# UNITED STATES PATENT AND TRADEMARK OFFICE

APPLICATION NO.	FILING DATE	FIRST NAMED INVENTOR	ATTORNEY DOCKET NO.	CONFIRMATION NO.
10/802,840	03/18/2004	Mikihiko Ishii	119132	5068
25944	7590	02/09/2005	EXAMINER	
OLIFF & BERRIDGE, PLC P.O. BOX 19928 ALEXANDRIA, VA 22320			LYONS, MICHAEL A	
			ART UNIT	PAPER NUMBER
			2877

**Office Action Summary**

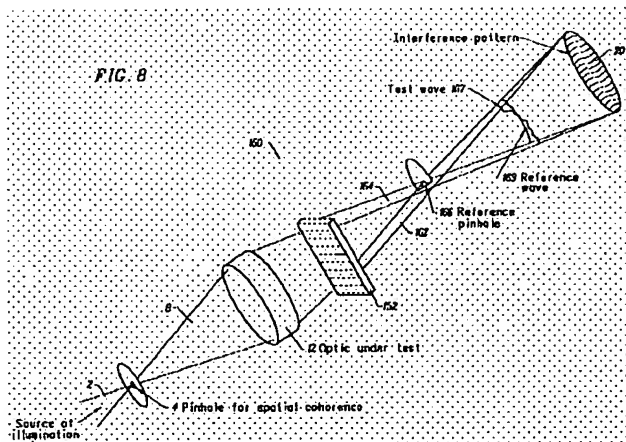
Figure 8 should be designated by a legend such as --Prior Art-- because only that which is old is illustrated. See MPEP § 608.02(g). Corrected drawings in compliance with 37 CFR 1.121(d) are required in reply to the Office action to avoid abandonment of the application. The replacement sheet(s) should be labeled "Replacement Sheet" in the page header (as per 37 CFR 1.121(d)) so as not to obstruct any portion of the drawing figures. If the changes are not accepted by the examiner, the applicant will be notified and informed of any required corrective action in the next Office action. The objection to the drawings will not be held in abeyance.
